- **THE RESOURCE MANAGEMENT ACT 1991**
- **PRIVATE PLAN CHANGE PPC85 – MANGAWHAI EAST**

**Review of Private Plan Change 85
Regarding Stormwater through
Windsor Way Lots 1-7**

Submitter Expert Evidence (Evidence in Chief – Consolidated)

Review of Private Plan Change 85 Regarding Stormwater through Windsor Way Lots 1-7

Figure 4: Inundation zone theorised for the proposal in 100 years (Coastal)

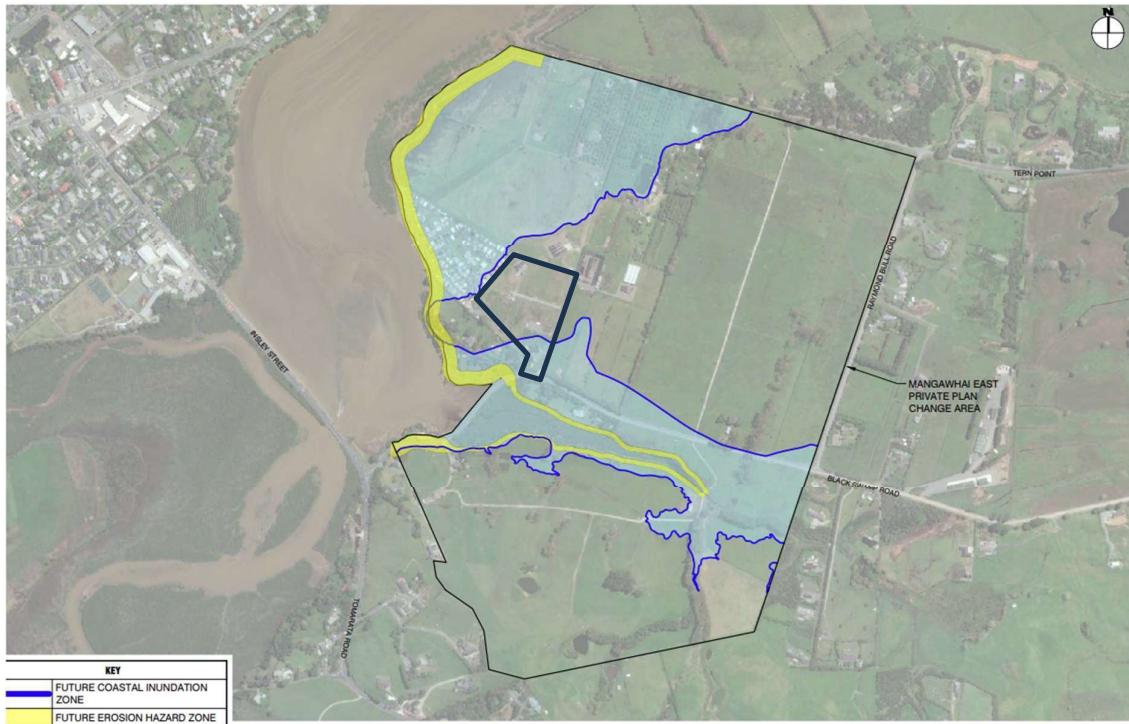
There is a predicted 100-year coastal inundation level (3.7 m RL) mentioned in the CABRAS report, which includes projections for sea level rise and vertical land movement. Lot 1 is located at the lowest point of the 7 lots (3.4 to 3.8 m). While the site is not currently affected by coastal erosion, Lot 1 is expected to fall within the inundation zone under 100-year + climate change scenarios.

Figure 5: Non proposed filling of the development to be 200mm above 100 year coastal innundation level

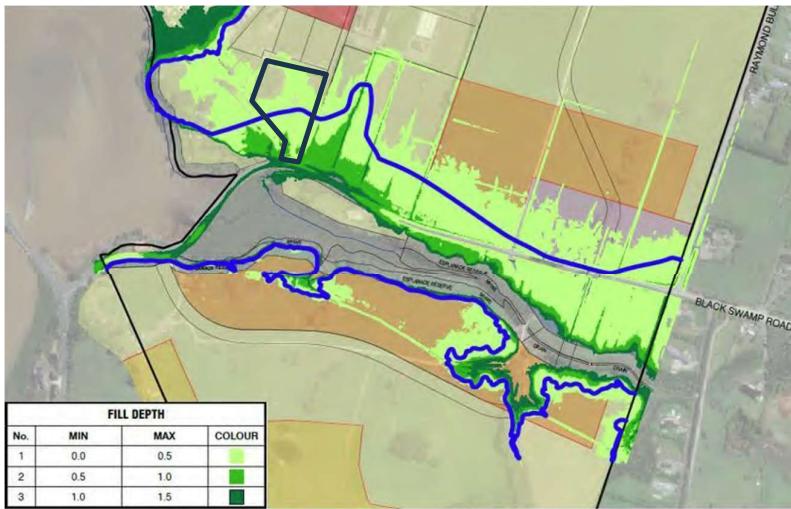
Although not formally proposed, the presence of this fill plan in the documentation suggests it may be reconsidered at a later stage. Given the site's already flat topography, even small increases in ground level may worsen surface drainage and exacerbate localised ponding.
